STAFF RECOMMENDATION

1501 Fatherland Street

Application: New Construction – Infill & Outbuilding

Description of Project: Application for the new construction of infill and a detached outbuilding.

Figure 2. Proposed front elevation

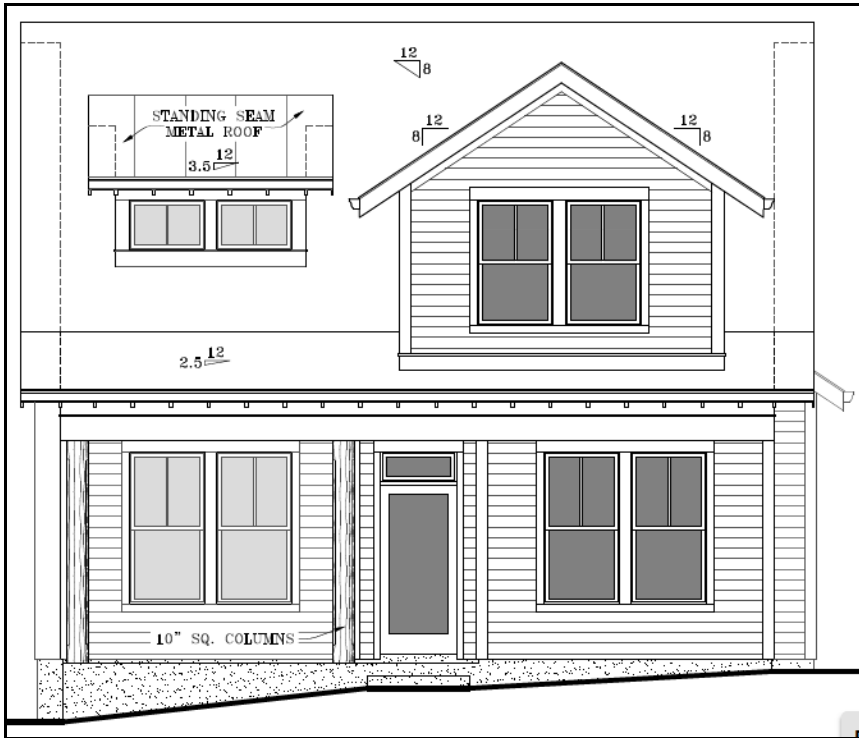
Width. The proposed width of the infill is twenty-eight feet (28') wide at the street. There is a true one-story, one foot by eight foot (1'x8') window bay on the left (street) side elevation which is a typical historic feature. Then about forty-two feet (42') back, the side wall steps two feet (2') wider. On the interior side elevation, the main massing steps about one foot, six inches (1'6") wider about twenty-eight feet (28') back from the front elevation. These bump-outs create a maximum building width of about thirty-two feet (32') for the rear portion of the house. Historic houses nearby contain articulation in plan as well and range from about twenty-four feet to thirty-two feet (24'-32') wide. Staff finds the proposed width to be appropriate.

Height – Ridge. The historic context in this vicinity includes true one story and one-and-a-half story houses. The heights of the historic houses range from about seventeen to about twenty-five feet (17'-25') tall, (with the pyramidal roof peaks of some houses rising a foot or two taller). Staff recommended to the applicant that they keep the overall height to a maximum of twenty-four to twenty-five feet (24'-25') from grade. They are proposing a ridge height of twenty-five feet (25') from foundation, or about twenty-six

feet, eight inches (26'8") from average front grade. The overall height is at the very top range of what might be appropriate for this site.

The design incorporates several dormers. The front elevation has a shed dormer over the porch. This dormer corresponds to the double window opening below, as is frequently seen in historic examples. It is mostly glazing, which is appropriate, and it is inset two feet (2') from both the side wall and the wall below, as required by the guidelines. A second dormer on the front elevation has a gabled form. This dormer is also inset from the right side wall. It sits two feet back from the front wall below, but on the left, it extends over the recessed porch. This side wall extending over the middle of the front door disrupts what is otherwise a symmetrical front façade. Further, the width of this dormer is out of scale for the house. To correct both the symmetry and the scale, the dormer could be narrowed and centered over the window opening below, which is seen in historic examples. Further, the gabled dormer should be moved back so that it sits fully on the gabled portion of the roof, rather than the shed portion – dormers are not appropriate on secondary roof planes, per the guidelines. See Figure 4. The third dormer is on the interior side elevation. This is a shed dormer attached to the rear of the primary side gable. Attached dormers are not seen historically, but this could be appropriate in this location on an interior elevation, far back from the front.

The primary entrance is oriented toward Fatherland Street and includes a partial-width recessed front porch that is eleven feet deep (11'). There is a porch beam that measures about two feet (2') tall. The front porch columns do not show bases or capitals – these should be added.

Figure 4. Interior side elevation. Arrow indicates where the dormer should be recessed beyond the change in roof pitch.

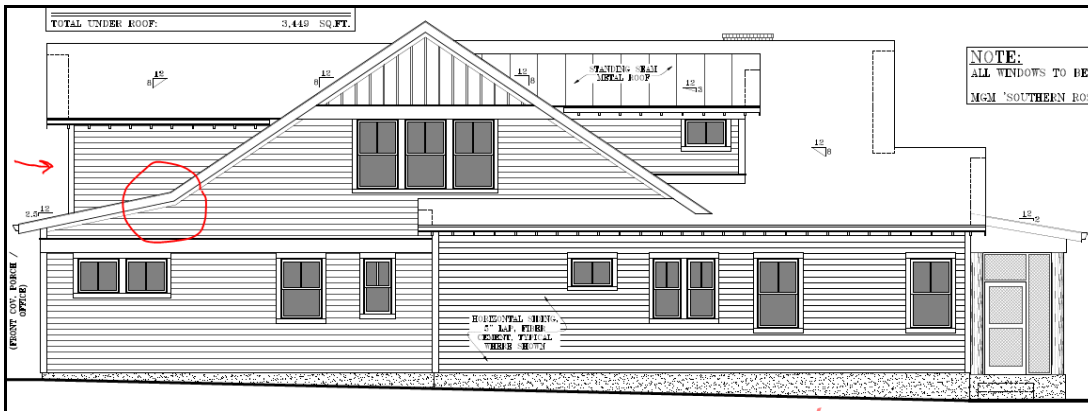
Height – Eaves. The lowest eave heights are about ten feet (10') from finished floor and are appropriate to a one-and-a-half story house. However, there are much taller eaves – particularly along the left side elevation- that are inappropriate for a one-and-a-half story house. The street-side elevation along 15th Street has the tallest eaves. See Figure 3. As measured from foundation, the eave flanking the chimney is about thirteen feet, three inches (13'3") and the eave of the side gable terminates at about fifteen feet, four inches (15'4"). In this context of one and one-and-a-half story houses and along this highly visible street-facing elevation, with significant slope that adds about three feet, six inches (3'6") of foundation height, these eaves are too high. An appropriate eave height would be more in the range of ten to twelve feet (10'-12') from foundation.

Figure 5. Proposed garage as seen from house. Note slope.

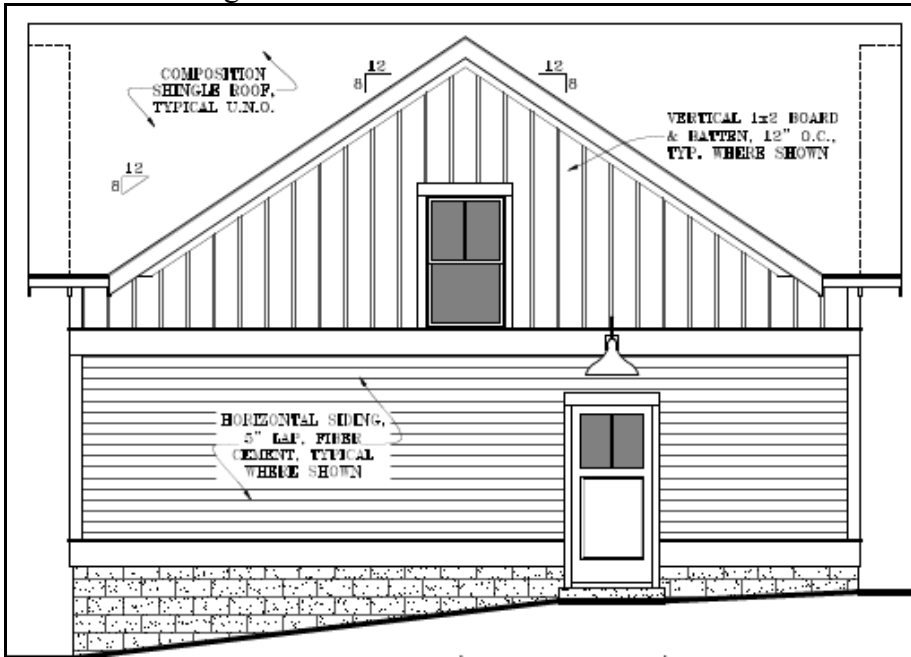
Because this is a corner lot, the ridge height of the outbuilding is limited to the ridge height of the primary structure. This house has a twenty-five foot (25’) ridge, so the proposed outbuilding height -which ranges from about twenty-one feet, six inches to

about twenty-four feet (21'6"-24') from grade - is appropriate. Staff finds that the outbuilding's massing and form to meet Section VII.B. of the Part I and the Lockeland Springs-East End chapter of Part II. of the consolidated design guidelines for the turn-of-the-century neighborhood conservation zoning overlays.
